Product Change Notification (PCN)

PCN #: 10H-2021

DATE: 11/3/2021

5.1 Base Part Number Changes (SIP Module Laser -Etching)

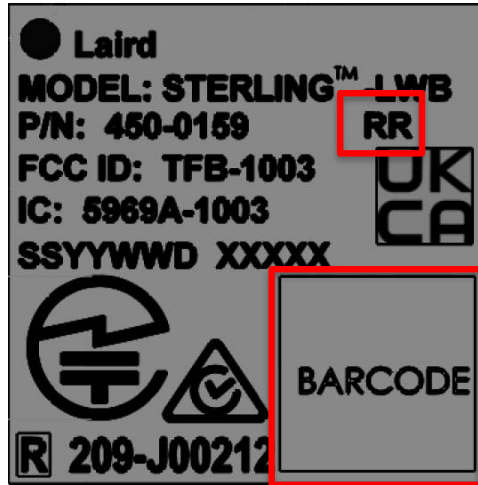
- Label/Laser-Etching updates have been to include the UKCA certification logo where room permitted.
- UKCA Logo added to module packaging labels (Tape & Reel, Cut Tape, and Carton).
- Upper-level assemblies have been up rev'd due to this change.

- Revision change available as revision number printed and within the barcode for all labels.

5.1.1 Antenna Option Label

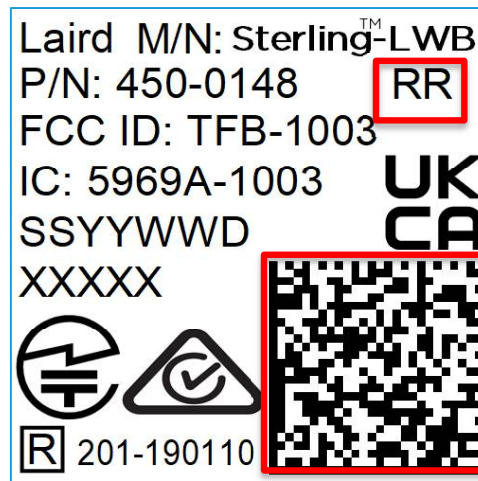
- Revision change available as revision number printed and within the barcode for all labels.
